# UNITED STATES PATENT AND TRADEMARK OFFICE

APPLICATION NO.	FILING DATE	FIRST NAMED INVENTOR	ATTORNEY DOCKET NO.	CONFIRMATION NO.
10/501,612	07/14/2004	Eric Sitbon		2221

<b>Office Action Summary</b>	<b>Application No.</b> 10/501,612	<b>Applicant(s)</b> SITBON ET AL.	
	<b>Examiner</b> Marcus Menezes	<b>Art Unit</b> 3677

## **DETAILED ACTION**

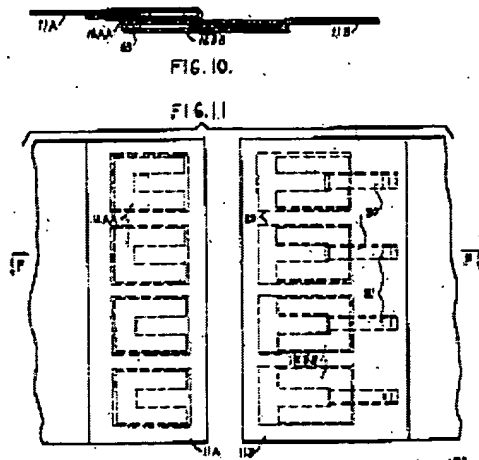
Regarding claims 1 and 3, Ellis discloses of an apparel fastener comprising of a first part equipped with at least one magnetic component (12BB) and a second part equipped with at least a second magnetic component (12AA). Ellis further discloses that this fastener is for securing clothing together. (See p. 1, col. 1, lines 1-5). Additionally, Ellis discloses that each magnetic component is composed of a magnet with positive and negative magnetic pieces, whereas the magnets of similar structure

are fixed directly or indirectly to the same support and are able to interact with magnetic pieces of opposite signs on a second magnetic component. (See Fig. 10 and 11).

Regarding claim 6, Ellis discloses of magnets (12AA) of the same component fixed rigidly among each other in an irremovable way. (See Fig. 11 above). Regarding claim 7, Ellis discloses of at least one component of magnets that are laid out in alternation between positive and negative magnets. (See Fig. 11 above). Regarding claim 8-9, Ellis discloses of magnets of the same component that are fixed side by side on the supports (11A, 11B) and of positive magnets on the opposite side of negative magnets, allowing for overlap of each magnetic component. (See Fig. 11 above). Regarding claim 14, Ellis discloses of a first sheath on support 11B where the first component is inserted and is mobile and within the sheath. (See Fig. 11 above). Regarding claims 16 and 17, Ellis discloses of a second magnetic component (12AA) that is fixed and of first and second components comprising of two sheaths. (See Fig. 11 above). Regarding claim 20, Ellis discloses that one of the first or second parts (11A, 11B) are formed by a strap. (See p. 1, col. 1, lines 1-5). Regarding claim 21, Ellis discloses that of a magnetic field is formed by the magnetic component on the apparel

strap. (See p. 1, col. 2, lines 70-73). Regarding claim 23, Ellis discloses of one or more flat magnets. (See Fig. 10 above). Regarding claims 24 and 32, Ellis discloses that each magnet is placed in an antimagnetic sheath that is capable of serving as an antimagnetic protection measure. Regarding claims 33 and 34, Ellis discloses of an elastic band (30) that is capable of detecting a closing or opening while serving as a release mechanism to control in the event specific conditions are not met.
